Victoria Point Manchester

Empiric Student Property PLC
NMA - Blocks 2-4 Amendments

16/01/2026
Issue 03

Non-Material Amendment

Typical Window Elevation

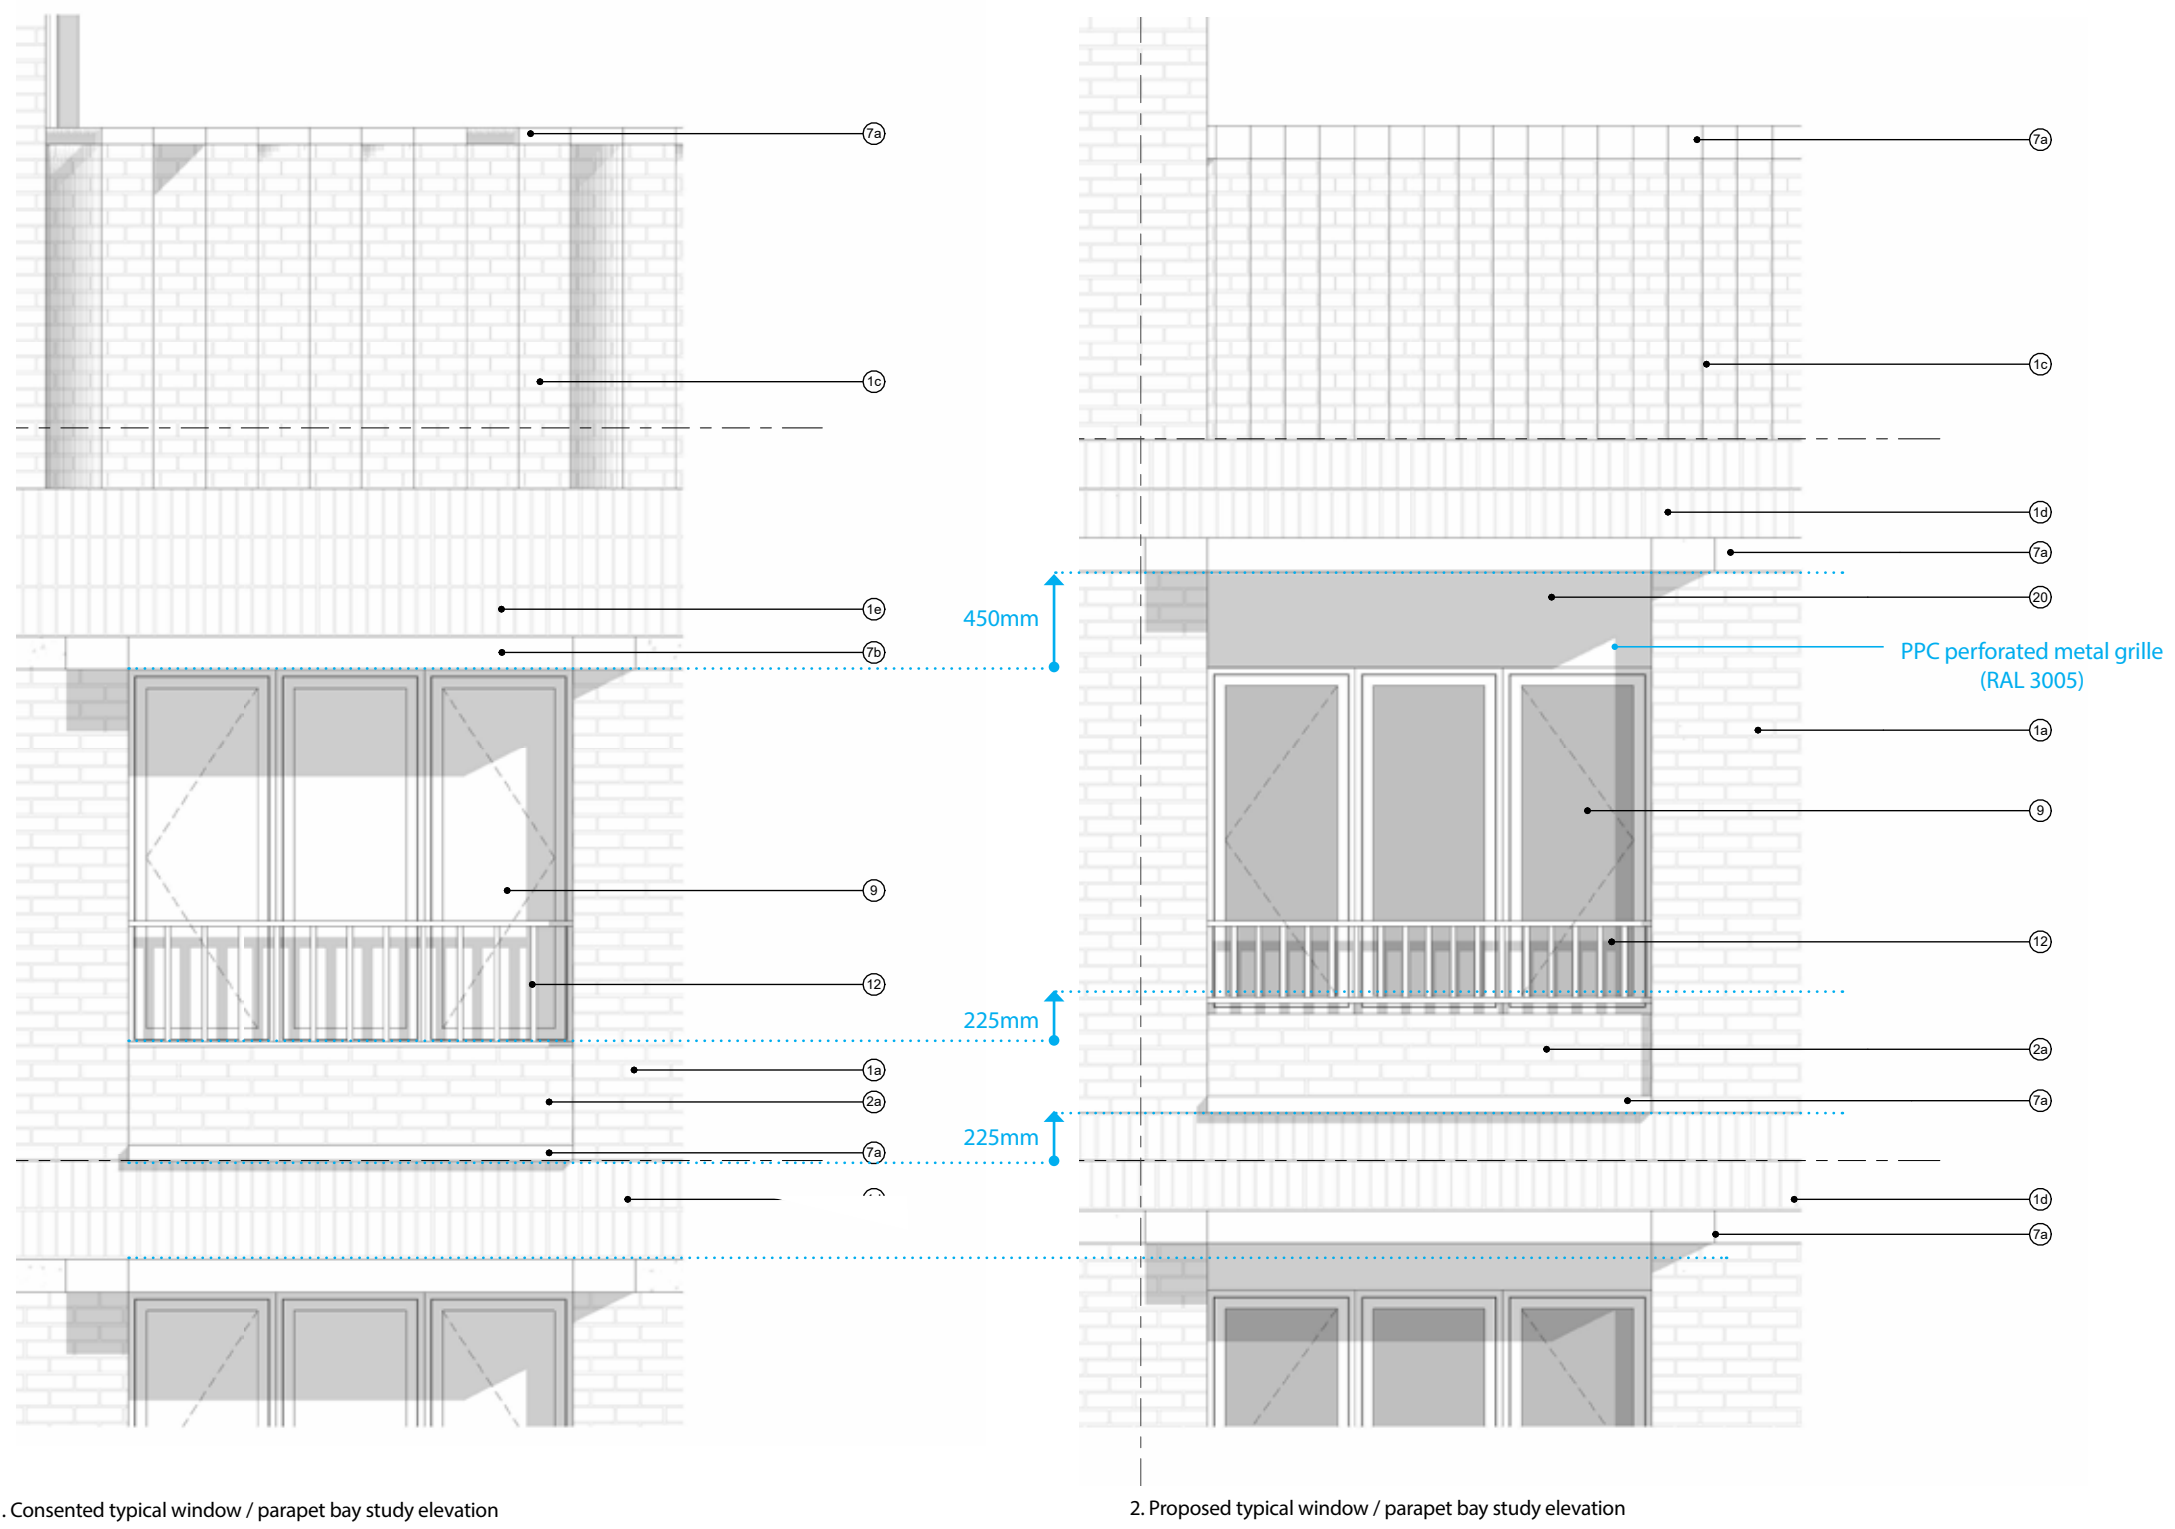
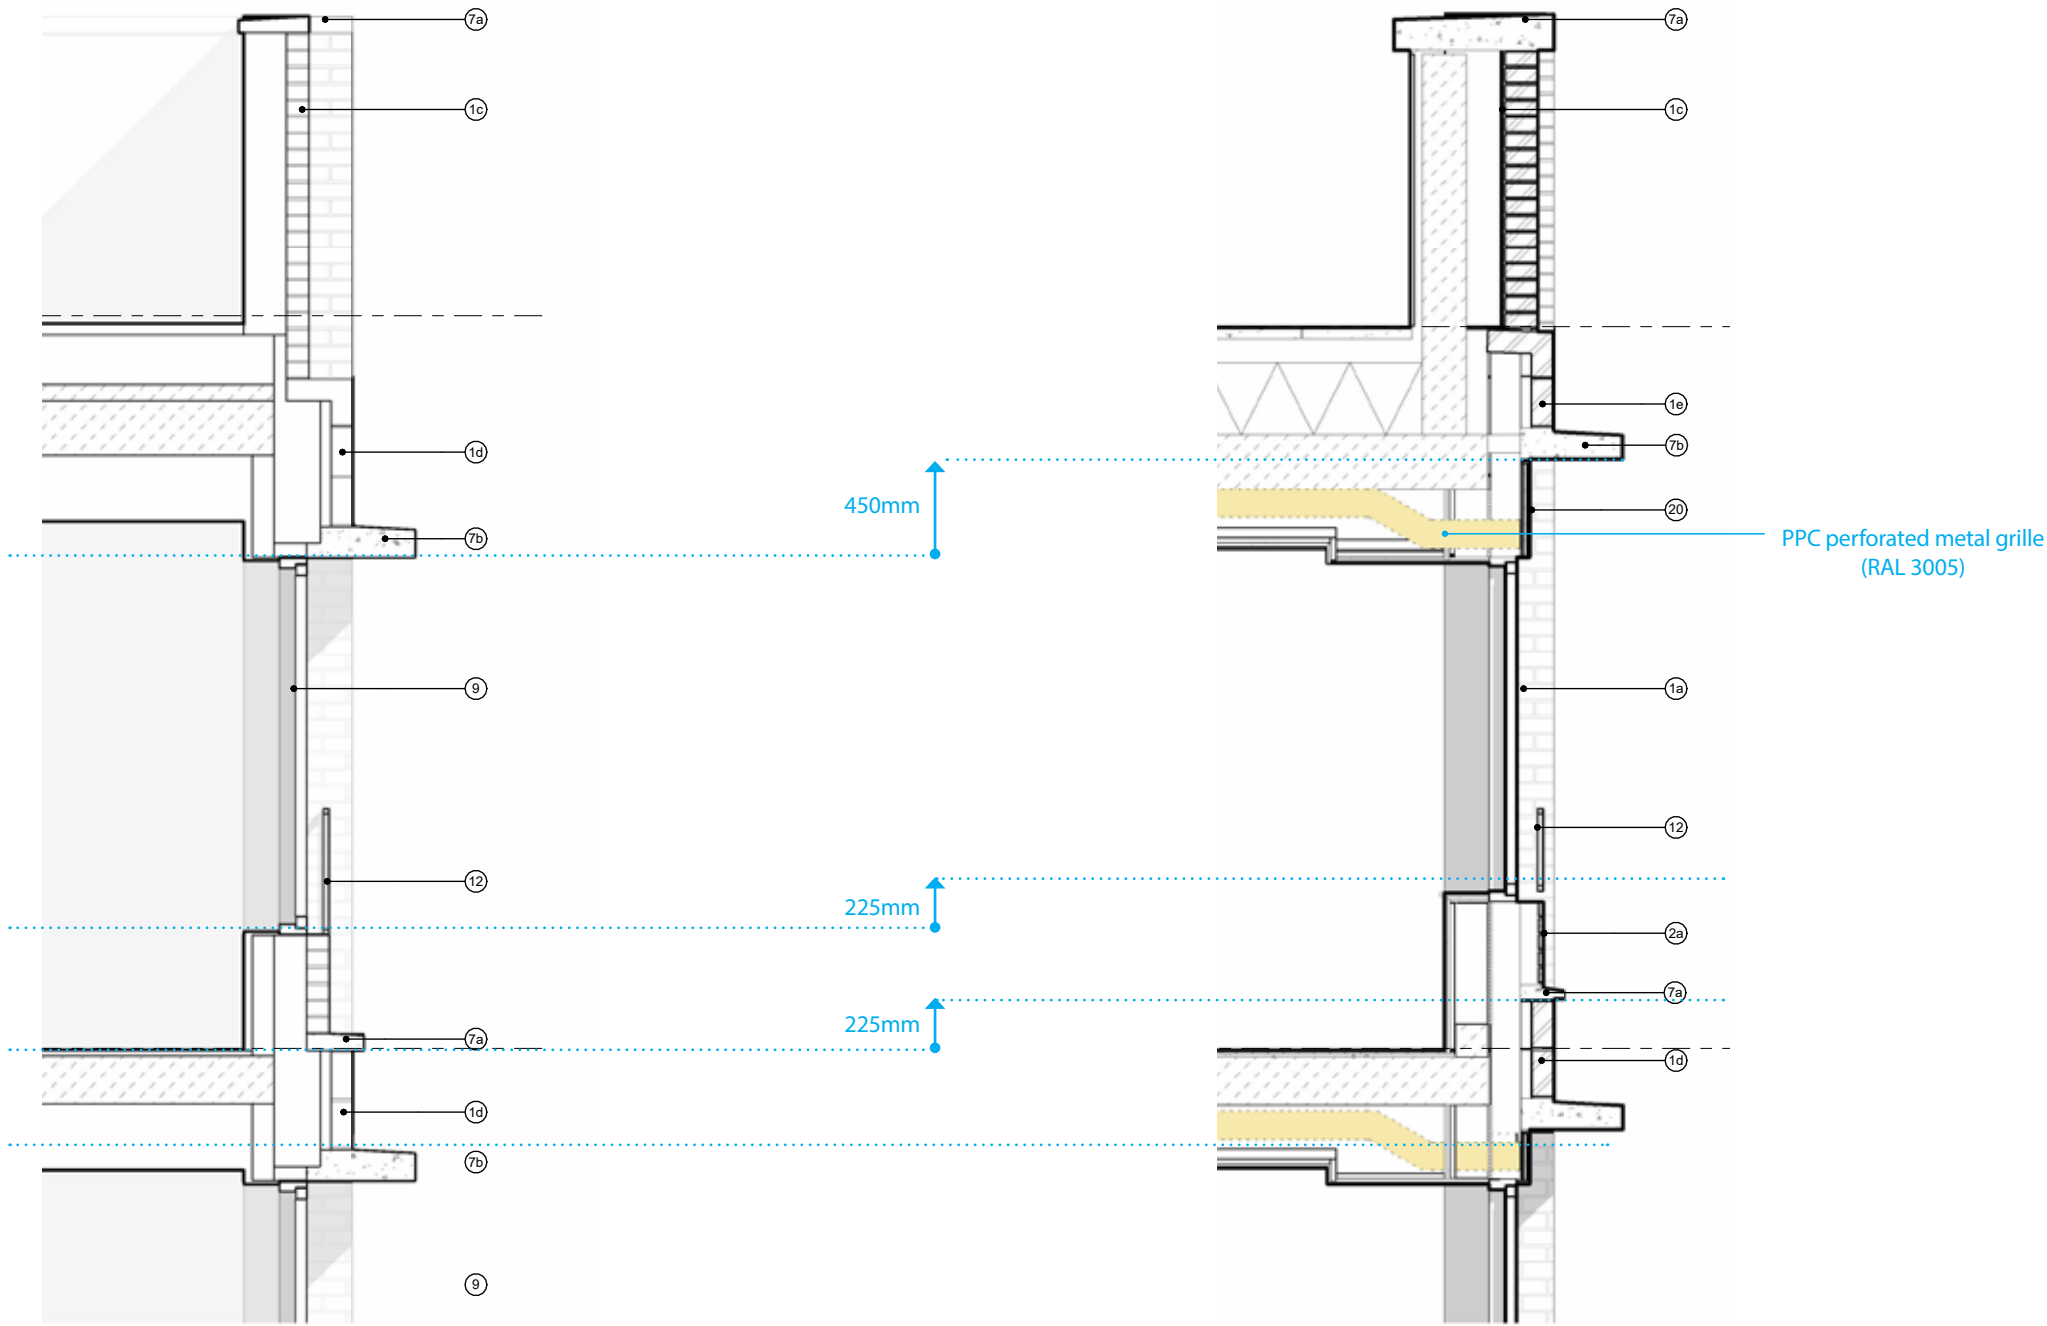
All windows have been revised to allow for MVHR & purge vent ducts to terminate above the window at a perforated metal grille. This maintains consistency and avoids having a series of brick air vents to the facade elevation.

To facilitate this, the precast banding has been moved up by 225mm and the double soldier course of brickwork has also moved up by 225mm resulting a slight shift to the window setting out.

Summary

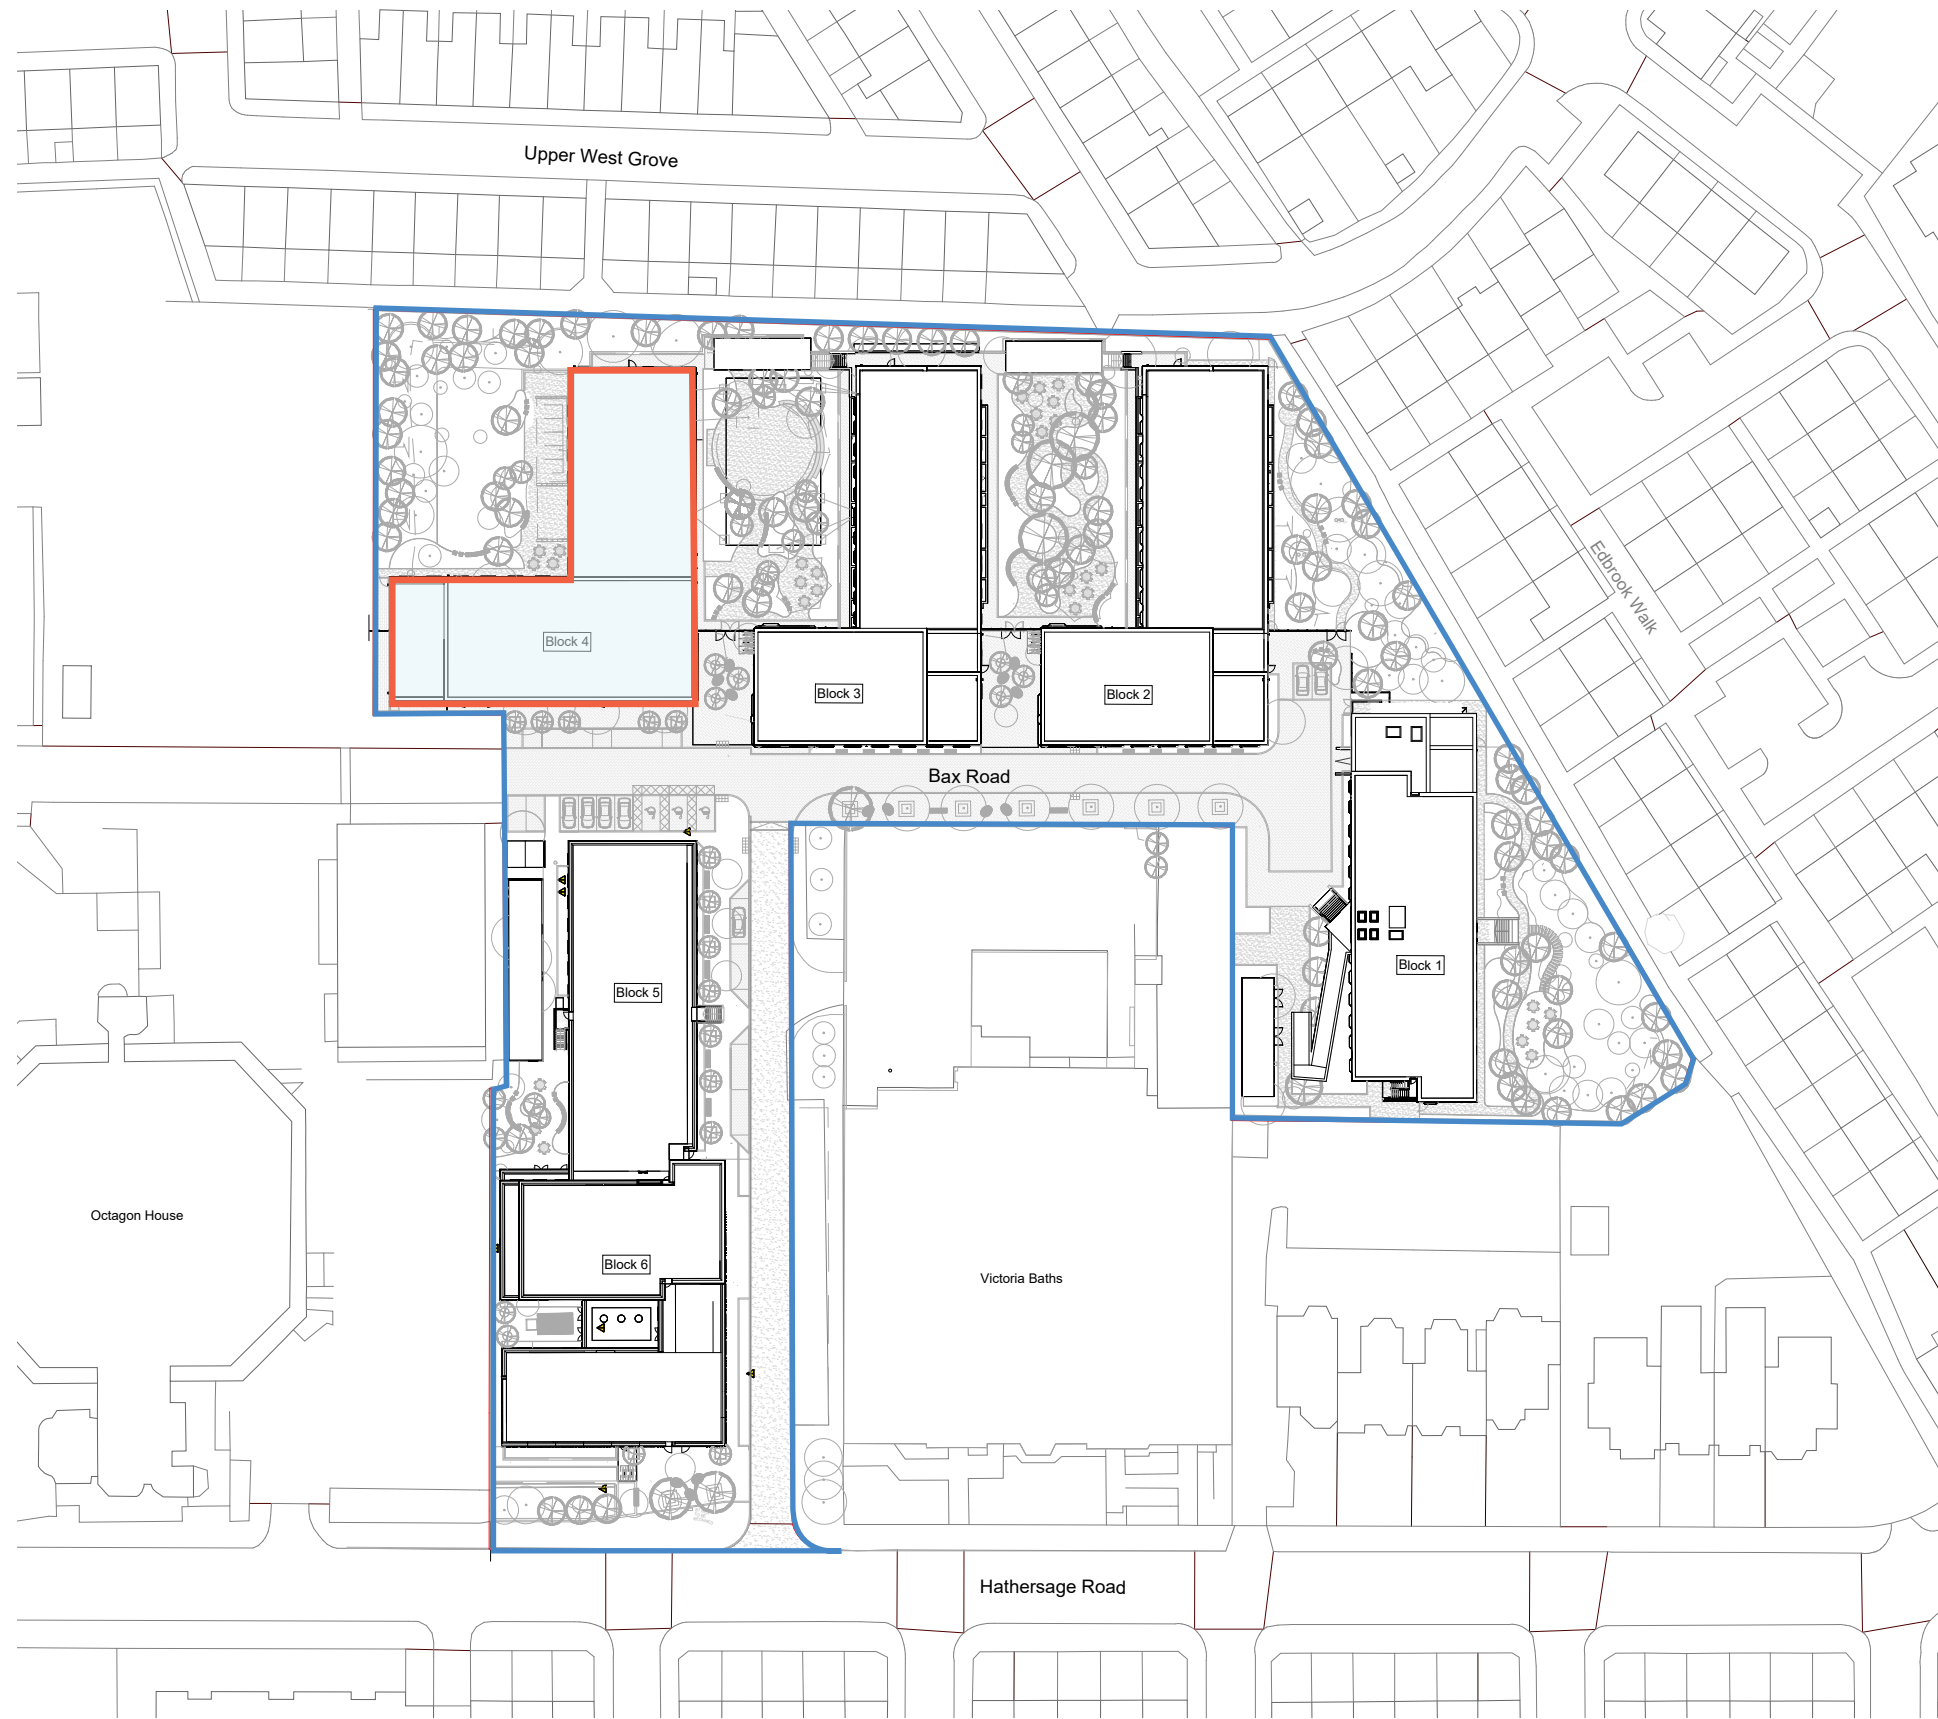
The changes required to Block 4 have been implemented in order to comply with BS9991.

- › the inclusion of evacuation lifts to all secondary staircases
- › an updated ground floor layout that includes a gym, yoga room, prayer room and meeting spaces
- › a revised basement layout which has seen the sprinkler tank room removed
- › the loss of 1 standard studio to allow for the evacuation lift and necessary escape path
- › updates to fenestration - as per Blocks 2 & 3
